Lonnie Atkins accelerometerDesignProjectFour Cell: Cantilever

Steve Coleman (SJC) Final accelerometer design Cell: Cantilever

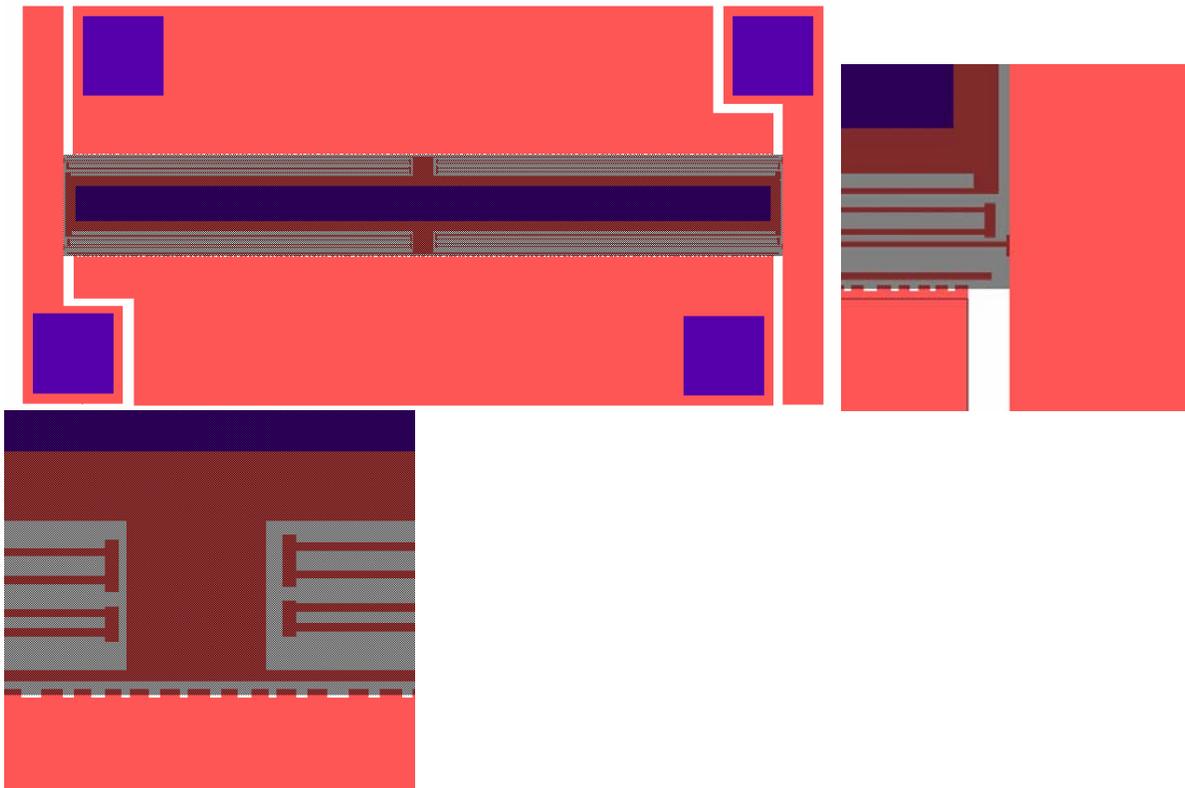
No INITIALS. I added LA.

The contact on the moving mass has winglike thin extension which will swing and cause trouble due to its vulnerability to bend. I shaved off the excess that can bend.

Very sloppy work. Tether beams are unevenly separated. Bits and pieces buried in beams. Unsymmetric /different pairs of tethers. **I worked on all. I am tired of all these corrections I had to make.**

Trench layer is wrong (supposed to be Nitride, he used oxide cut instead) **I corrected that. Also, increased the size for extra margin. 10 um in each direction.**

Blanket metal over the contacts **is needed. 700 x 500 um is added to cover the contacts.**

Initials are missing. Done.

New tethers replaced the originally drawn, completely. Tethers are reduced to 500 um long. (rule)
Center of mass expanded by expanding the contact to a width of 600 um.

Contact gaps of 3 u and 4 u are maintained.

Corrected New : LA-x x Cell: LA-XX

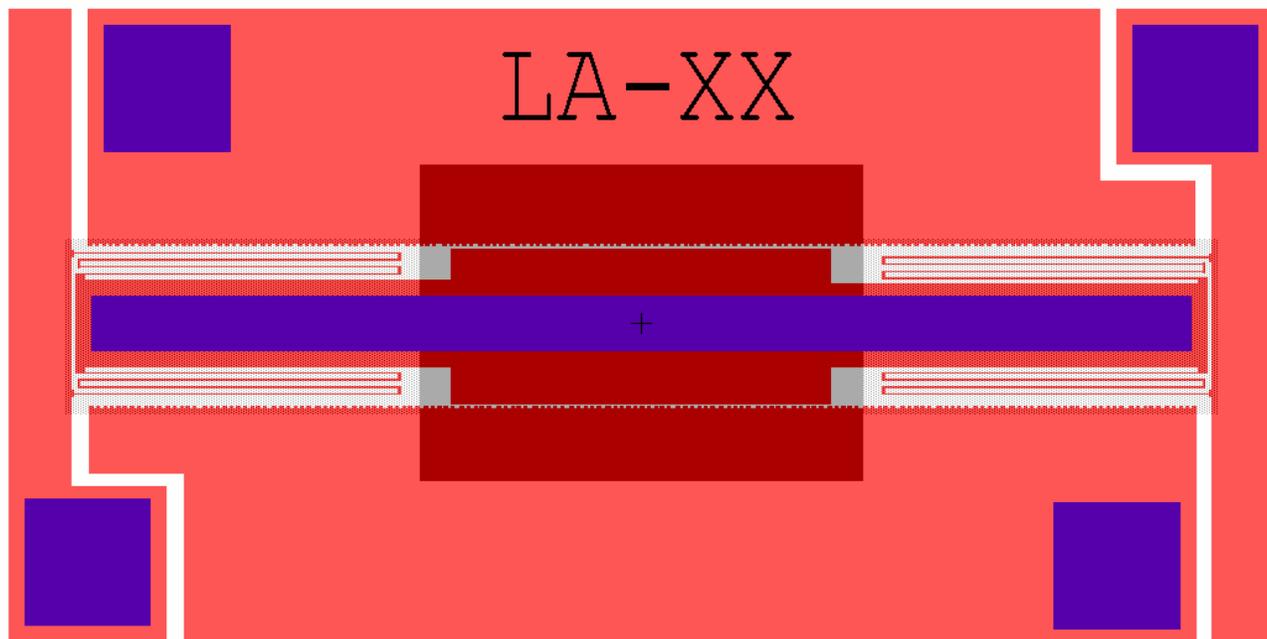
Initials in second poly: Correct it to Metal 1.

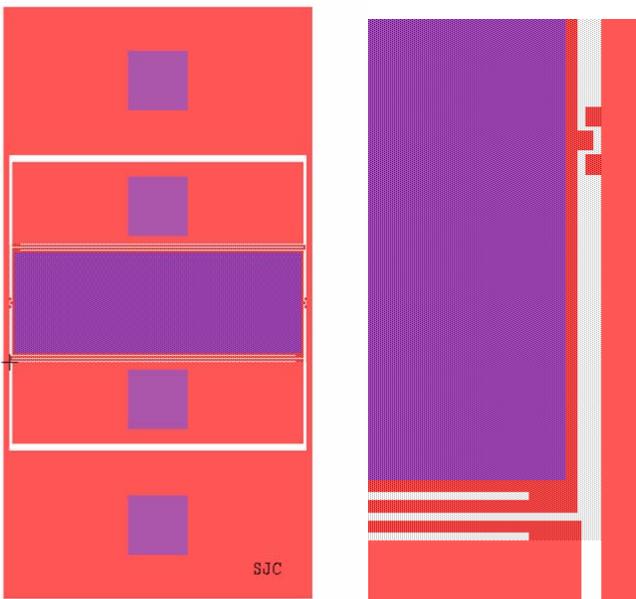
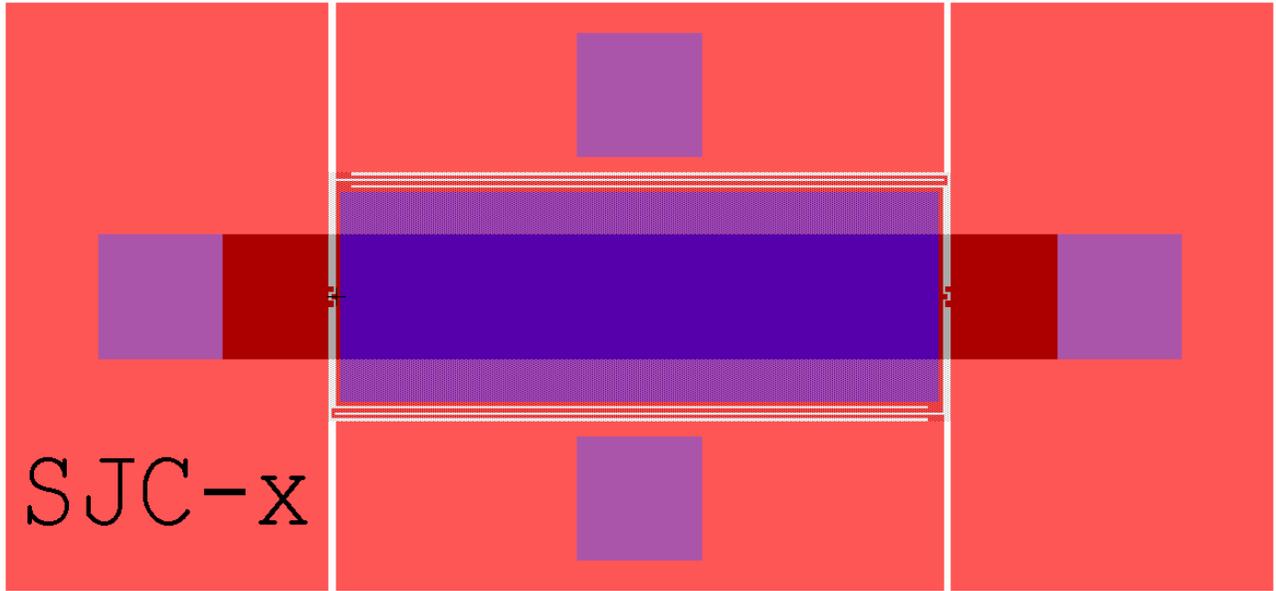
Initials Port in Second Poly (ie Blanket Metal) Layer which is impossible for fine lines (It **has to be done in Metal 1** for fine line) **Done.**

No distinction for direction. Opposite switches are electrically joined. No margin for extra swing, either. The switch contacts may break at high impact. **I will not correct that.**

Both switches have **high resistance** paths of current to terminal pads. Right and left switches **need to be separated. Accomplished by moving the SOI pieces from top bottom to left/right. Done.**

Blanket metal over the contacts **is needed. 100 um minimum can be met while reducing the high resistance. Done.**

Corrected to: Final accelerometer design X Cell: SJC-X

Corrected New : SJC-x Cell: SJC-X

Greg Mitchell 2_Tether Design Cell: Cantilever

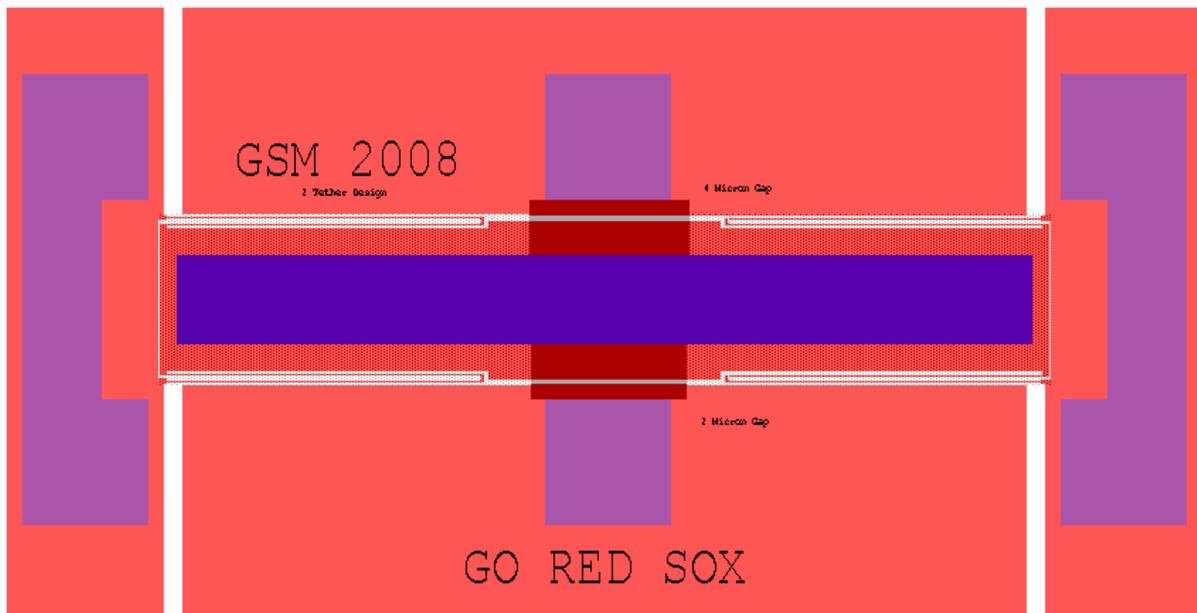
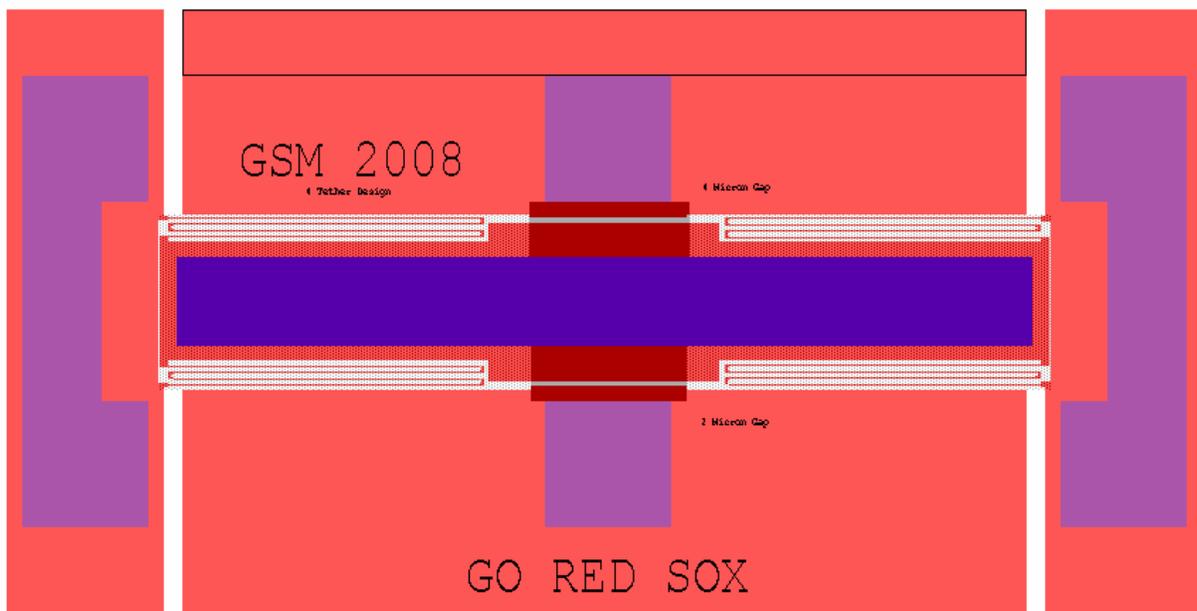
Letters written at < 200 size will not show. **(Not Fatal)**

Tethers are fine ($445 < 500$ um max for 2um wide beams). I will not change them.

Upper right block of SOI height reduced to 222 u to increase margin to tether and to make it same as the one on the left.

Trench: is readjusted to 1430x283 to accommodate gaps and alignment with SOI edges (5 um into SOI in all 4 directions). **Done.**

Blanket metal over the contacts **violates** the (100 um minimum) (It is 89 um) **I increased their heights to 110 um with no change of mass on the moving body .**

Corrected to: GSM2T-x

Tom Zack Accelerometer3 Cell: Cantilever

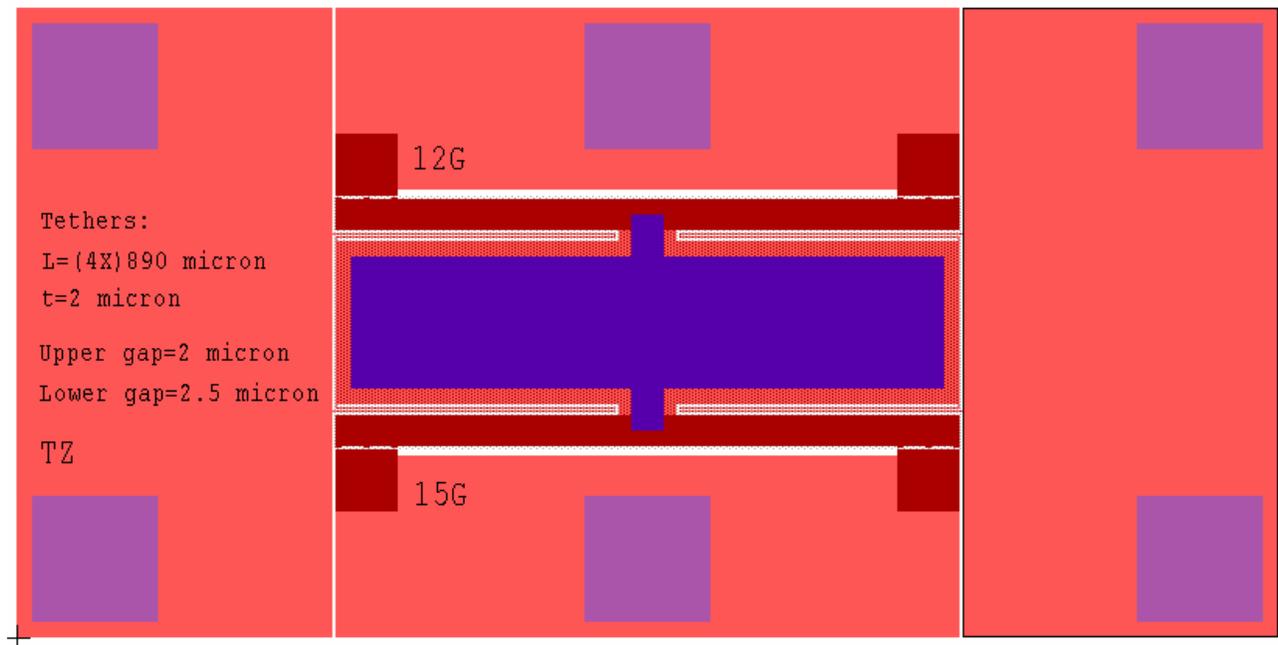
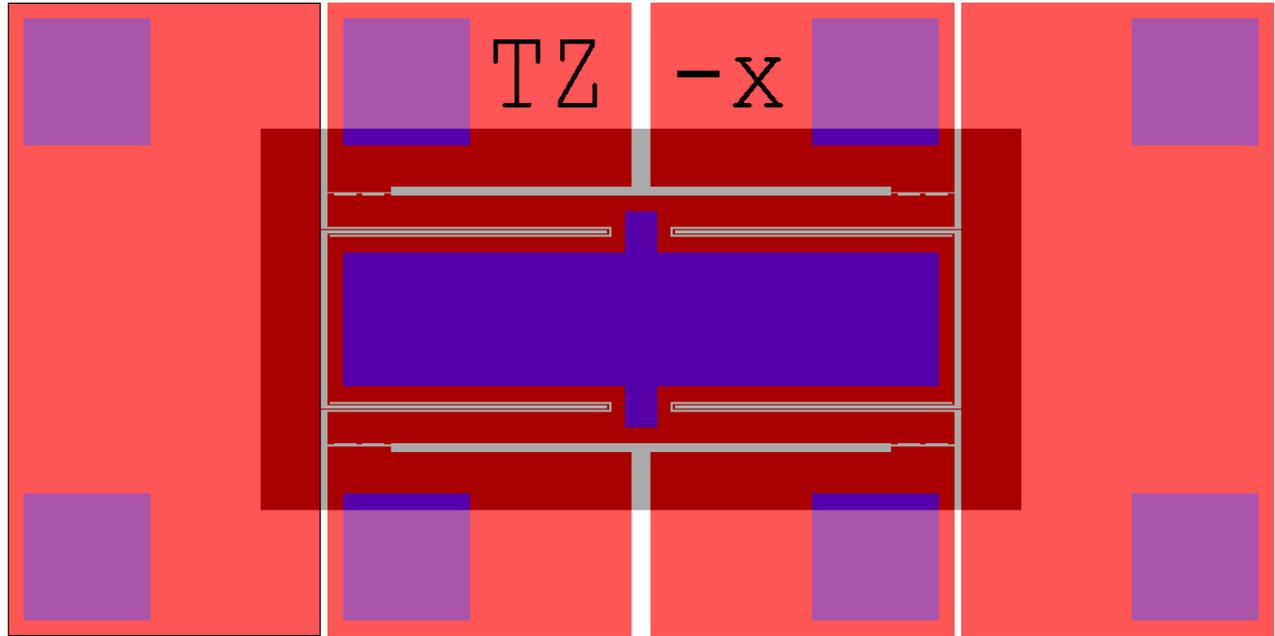
Blanket metal violates 100 um rule (only 49.5um high strips and also about 45 um separations)

Ports are on Blanket gold (violates 100 um rule, change it to Metal 1.

Ports are in Blanket Metal (they violate the minimum 100 um rule). Change it to **Metal 1** layer for fine line **Done.**

Tethers are fine ($445 < 500$ um max for 2um wide beams). I will not change them.

Pairs of contacts on opposite sides are connected in parallel. Confuses measurements if off-axis acceleration or spinning takes place. It is better to split contacts to two separate electrical bonding pads. **Done.**

Moving part has too small gap to stationary side SOI's blocks. Increase those gaps to >10 um to prevent friction. **(I made the gaps 10 um on each side)**

Trench: is readjusted to 1010×420 to accommodate gaps and alignment with SOI edges. **Done.**

Tethers had to be lengthen to span the increased gaps. **DONE.**

Blanket metal over the contacts **violates** the (100 um minimum) (It is 61 by 67 um) **I added a full cover of 1200 um x 600 um . TOM has to readjust his calculations.**

Corrected to: TZ-x Cell: TZ-X

New : TZ-x Cell: TZ-X

Stephen Nelson SFN 1x1 Contact to Specf Cell: Cantilever

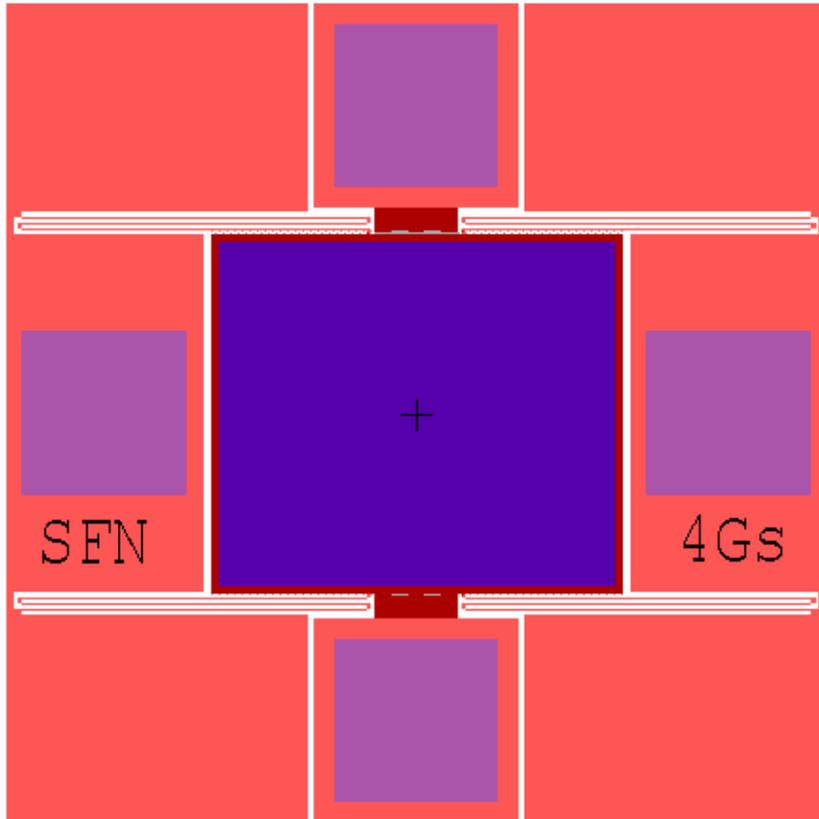
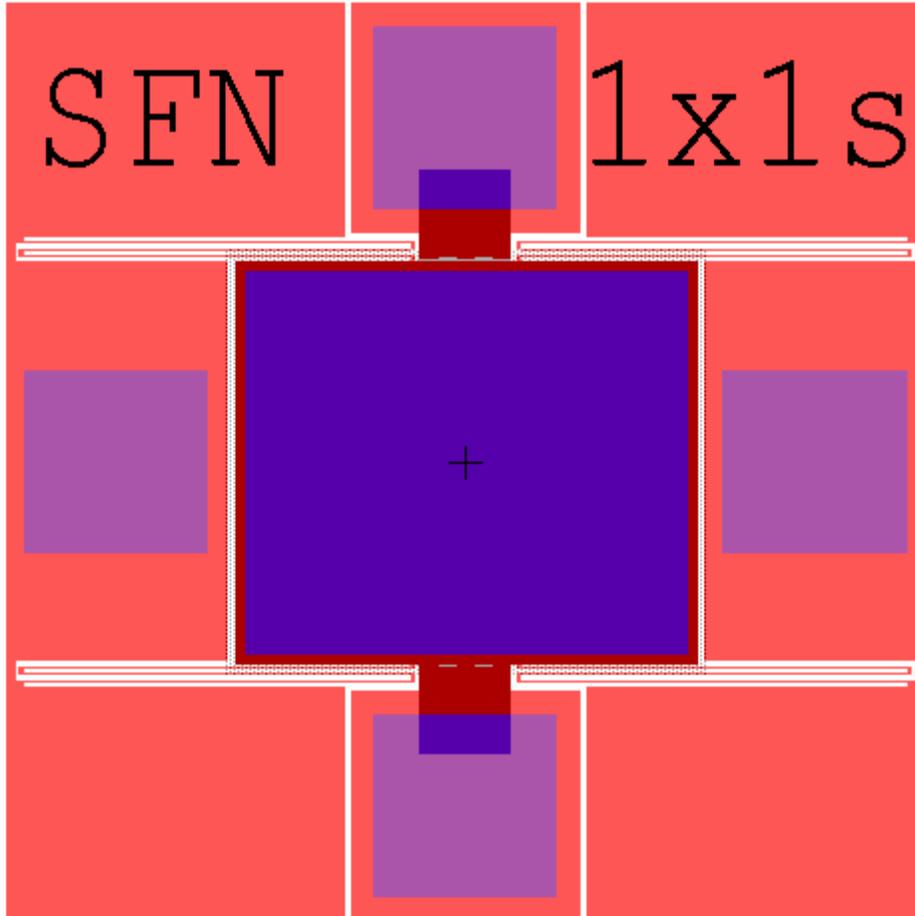
Ports are in small (they violate the minimum 3 um rule). Change isizes to 200 units. **Done.**

Trench: needs a margin > 5 u. I extended the original size by 10 um in both directions finally becoming adjusted to **2x263x2x232** to accommodate gaps.and alignment with SOI edges. **Done.**

Blanket metal over the contacts **violates** the (100 um minimum) (It is 100 by 62 um) **I increased it to 100 u x 100u.**

Corrected to: SFN1x1S -x Cell: SFN1x1S

Corrected New: SFN1x1S-x Cell: SFN1x1S

Stephen Nelson SFN 1x1 Contact Cell: Cantilever

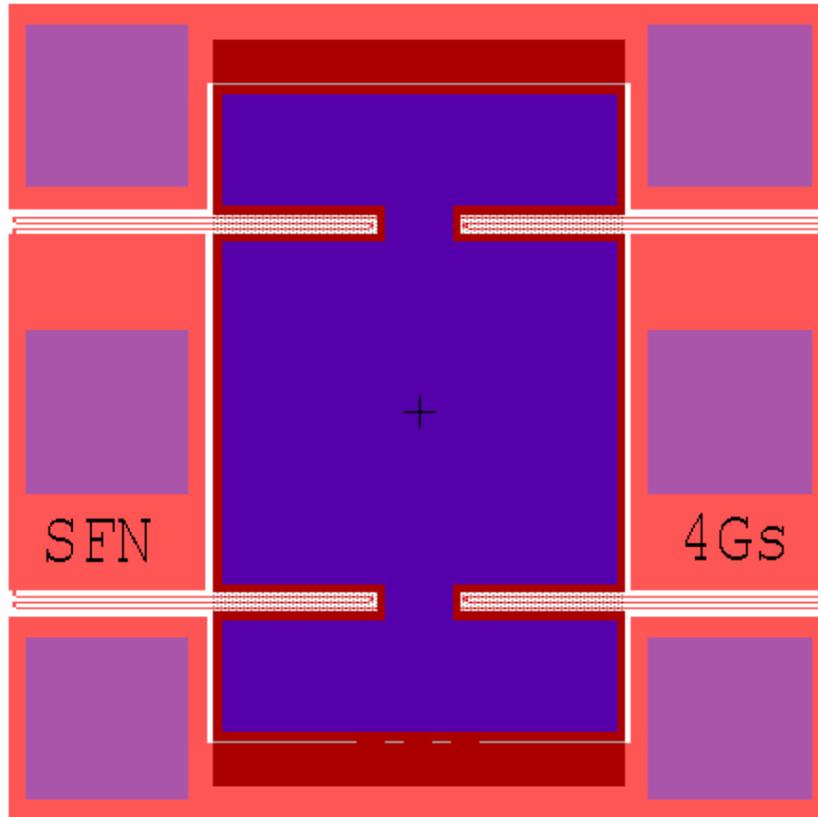
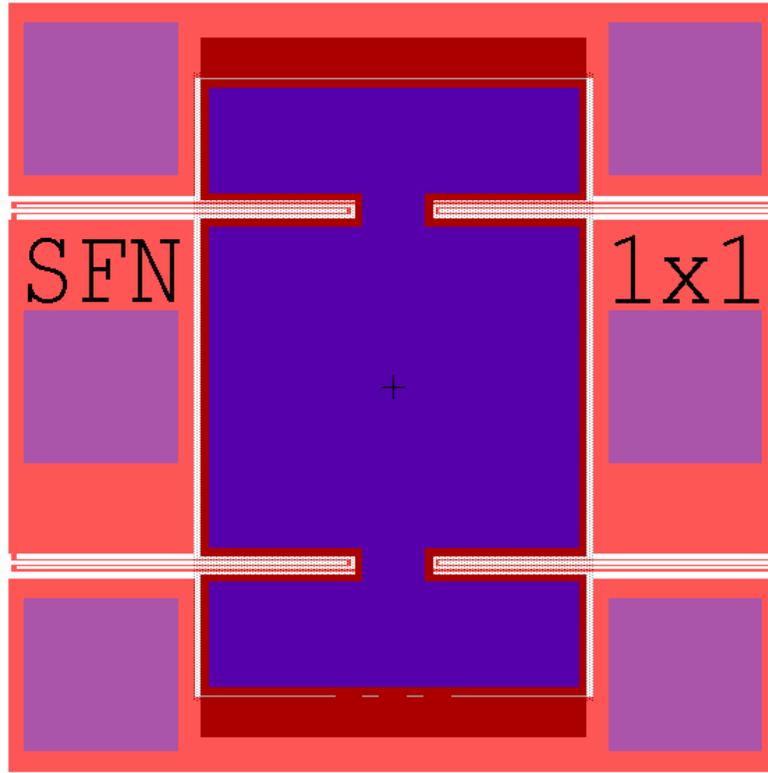
Ports are in small (they violate the minimum 3 um rule). Change isizes to 150 units. **Done.**

Trench: needs a margin > 5 u. I extended the original size by 10 um in both directions finally becoming adjusted to **2x260x2x410** to accommodate gaps.and alignment with SOI edges. **Done.**

Corrected to: SFN1x1 -x Cell: SFN1x1S

Corrected New: SFN1x1-x Cell: SFN1X1-X

Corrected to: JVC-x Cell: JVC-x

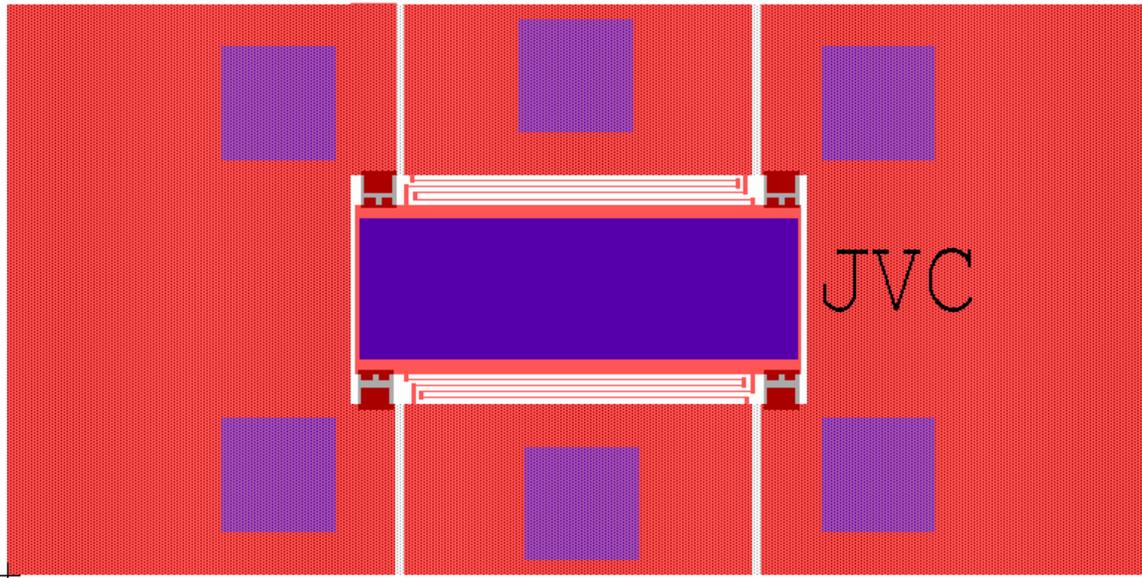
Port in Nitride Layer (Trench) which is impossible (**needs to be done in Metal 1** for fine line) **Done**.
Large and small gaps are connected in parallel. Confuses measurements. SOI patterns need to be **split apart** for electrically separated terminals. (**I left 20 um gap for isolation**)
Trench: is drawn as Not-Nitride (800um * 400 um). **Trench pattern needs to be inverted**.
Tether pieces touch each other before a contact is made (9 and 12 um contact gaps, 6 um room to touch between tethers). **I trimmed all excess supporting pieces for stress at tether joints and reduced contact gaps to 4 um and 6 um**. Otherwise it would fail.
Excess SOI piece to be reduced by 1 um (not critical) **Done for beauty**.
Blanket metal over the contacts **violates** the (100 um minimum) (It is 61 by 67 um) **I have increased it to 140 um x 450 um on both pairs of contacts**.
